Service Bulletin

Bulletin No.: PI1142

Subject: Front Floor Console Extension Side Panel Change

Models: 2014 Chevrolet Impala
Vehicles Built Prior to November 1, 2013

3670485

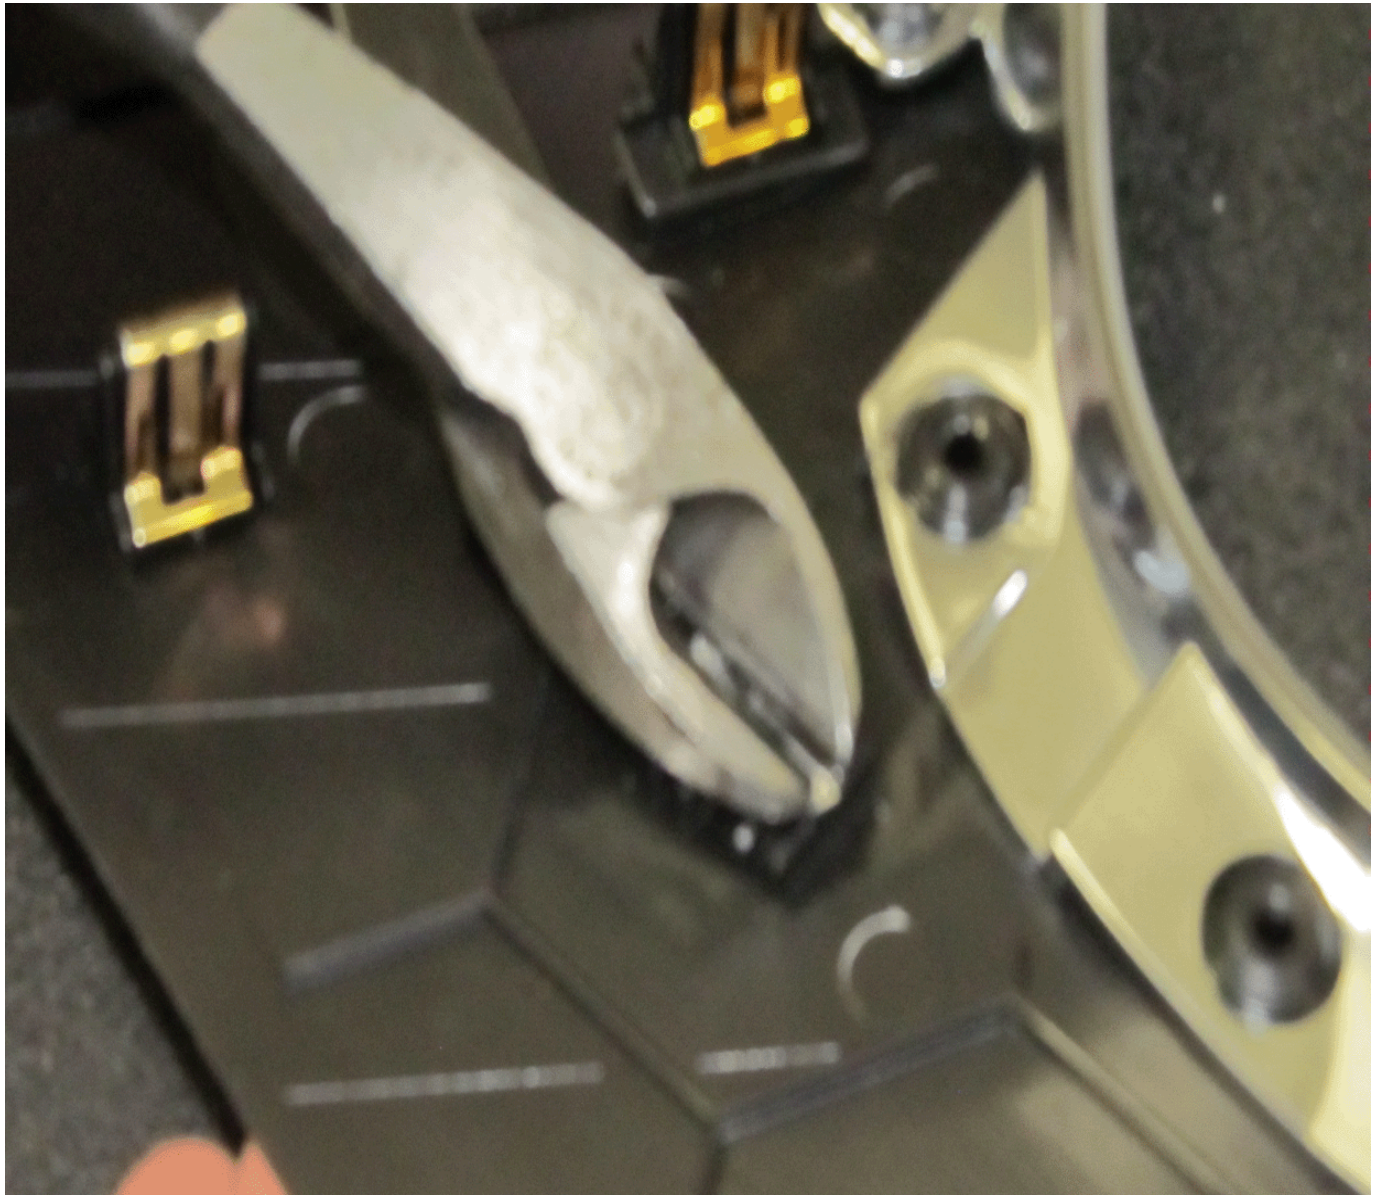
The purpose of this PI is to inform the technician that when replacing the front floor console extension side panels, the new panels come with an additional clip tower, shown in the illustration above, that needs to be modified for vehicles built prior to the date listed above.
